ASSESSMENT REPORT – COMMERCIAL DEVELOPMENT S79C – Environmental Planning & Assessment Act 1979

DA No:	DA/305/2013
Assessment Officer:	Kate Lafferty
Property:	30 Phillip Street – Parramatta Lot 2 in DP730119
Proposal:	Alterations and additions to the Park Royal Hotel, including the construction of an 8 storey addition containing 90 rooms, additional function space/meeting rooms and restaurant/bar areas
Cost of works:	\$20,361,000
Date of receipt:	24 May 2013
Applicant:	Success Venture Pty Limited
Owner:	Success Venture Pty Limited
Submissions received:	No submissions received
Property owned by a Council employee or Councillor:	No
Council application:	No
Issues:	Building separation (LEP2007) Activation of laneway
Recommendation:	Approval subject to conditions

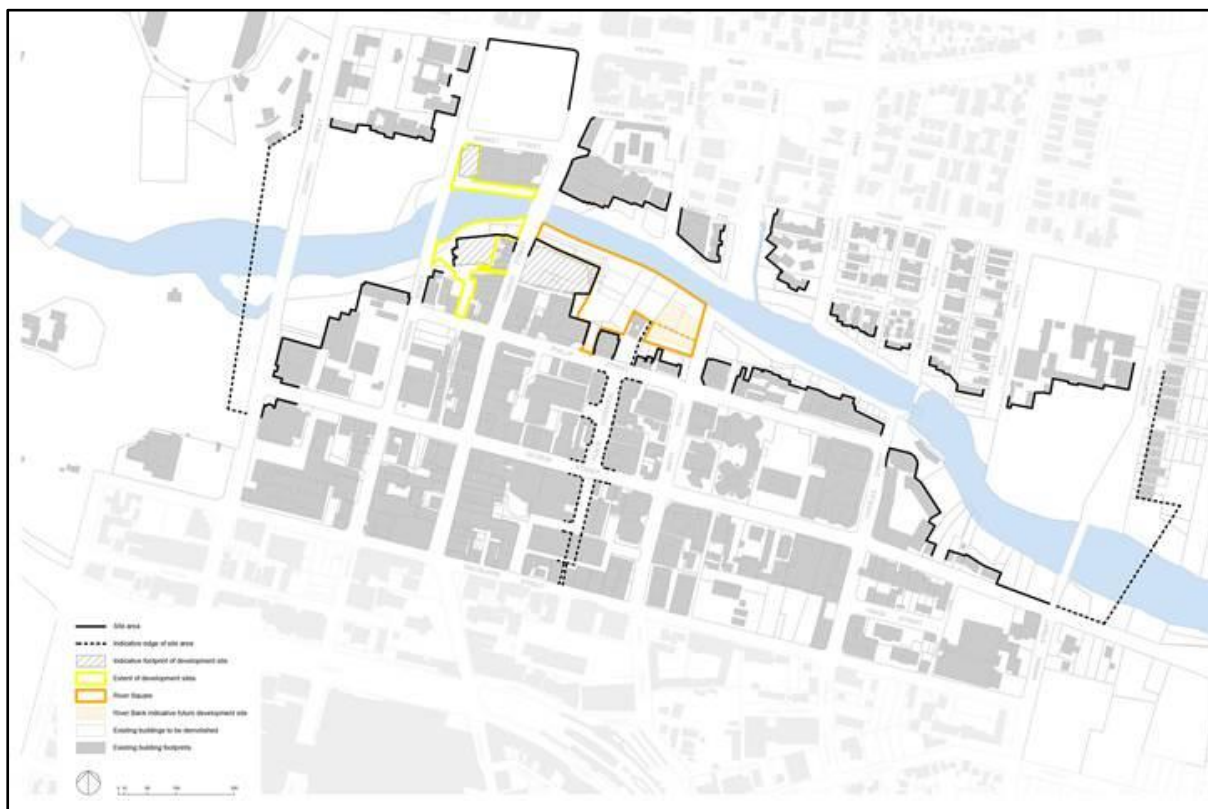
The site is located directly on the primary access to the river foreshore from Phillip Street – this access way is the main entry to the future River Square and subject to a large amount of foot traffic for events such as the New Year’s Eve fireworks, Loy Krathong festival and other activities hosted by the City of Parramatta. Therefore the presentation of the building frontage along this access way is very important.

Concerns are raised within this assessment report regarding the lack of activation of the proposed development on the eastern side of the building, adjoining the existing laneway. Council officers have requested that this corner be activated by such means as providing window openings along the existing eastern wall on the ground and 1st floors (with a minimum 10% of wall glazing). The applicant has chosen not to provide any amended plans indicating the activation of this space primarily due to the additional cost that this would entail. The laneway is currently listed as private

land (not a public road) and as such, any windows on the boundary would require fire protection in the form of a sprinkler system.

It is therefore recommended that a condition of consent be imposed requiring the submission of plans/elevations indicating the activation of the eastern elevation of the building before the issue of a Construction Certificate. It is further recommended that a condition be imposed with a “sunset clause” requiring these works be carried out should the laneway become a public road within the next 5 years.

Figure 1: Location of columns in the basement car parking area

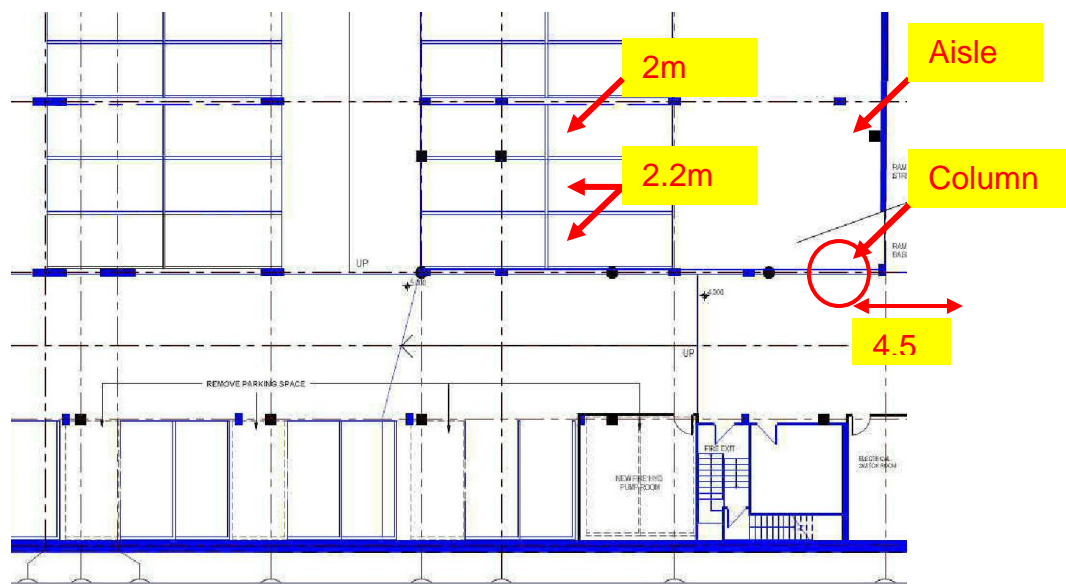
<p><i>Parking Spaces – Layout and dimensions (Section 2.4 of AS 2890.1-2004; AS 2890.6-2009; and Part – 3, Section – 2 of AS 2890.3-1993)</i></p>	<ul style="list-style-type: none"> – The submitted DA application has already removed 12 spaces from the southern boundary of the property – However, 8 additional car parking spaces are need to be removed to comply with the AS2890.1-2004 (refer to Figure 1 below) – 1 column is located at the middle of the and therefore vehicles will not be able to access car parking spaces 	<p>According to AS2890.1-2004</p> <ul style="list-style-type: none"> – 2.4m is the minimum required width for car parking spaces for standard vehicles – Columns are not to be located within the design envelope for structural elements to be clear of all four side doors – A signs is required to be 	Additional 8 car parking spaces (on basement levels 1 & 2) do not comply with AS2890.1-2004

from the southern end of the aisle	installed on the column to advise motorists to access car parking spaces from the northern end of the aisle.	
Traffic generation - RMS Guide to Traffic Generating Developments (TGD) and Technical Direction (TDT 2013/04a - August 2013)		There is no increase in the number of car parking spaces for the proposed development. So, there will not be a significant impact on Phillip Street or the surrounding road network.	Yes

- *The layout of car parking spaces located near new columns to support Banquet pre-function room is to be modified to comply with AS2890.1-2004.*
- *Relocation of any parking signs requires approval from Parramatta Traffic Committee and Council. Relocation of any bus stop plinth requires approval from Transport for NSW. All costs associated with the supply and installation or relocation of signs and/or plinth are to be paid for by the applicant.*
- *Subject to the recommended traffic related conditions.*

10. Parking spaces are to be provided in accordance with the approved plans referenced in Condition 1 and AS 2890.1, AS2890.2 and AS 2890.6. Details are to be illustrated on plans submitted with the Construction Certificate. Note that the layout of car parking spaces located near new columns to support Banquet pre-function room is to be modified to comply with AS2890.1-2004.
